Model 2461 High-Current SourceMeter® Instrument
2461-NFP
2461-RACK
2461-NFP-RACK

VERSION 1.7.18 RELEASE

PR61502 From a cold power up, the Model 2461 SMU will sometimes fail with the following error message and will not operate properly.

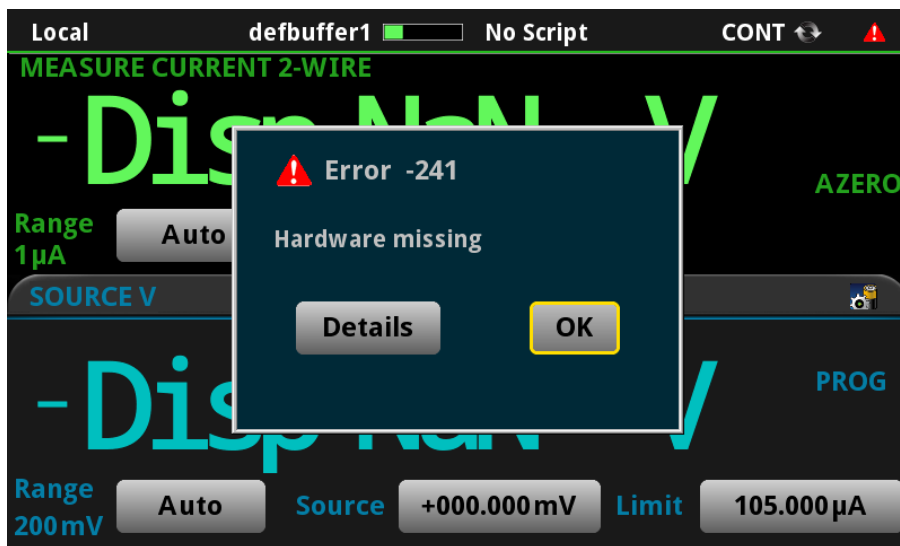
If this issue occurs, a subsequent power cycle will allow the instrument to power up properly.

This issue has been corrected with firmware revision v.1.6.5.
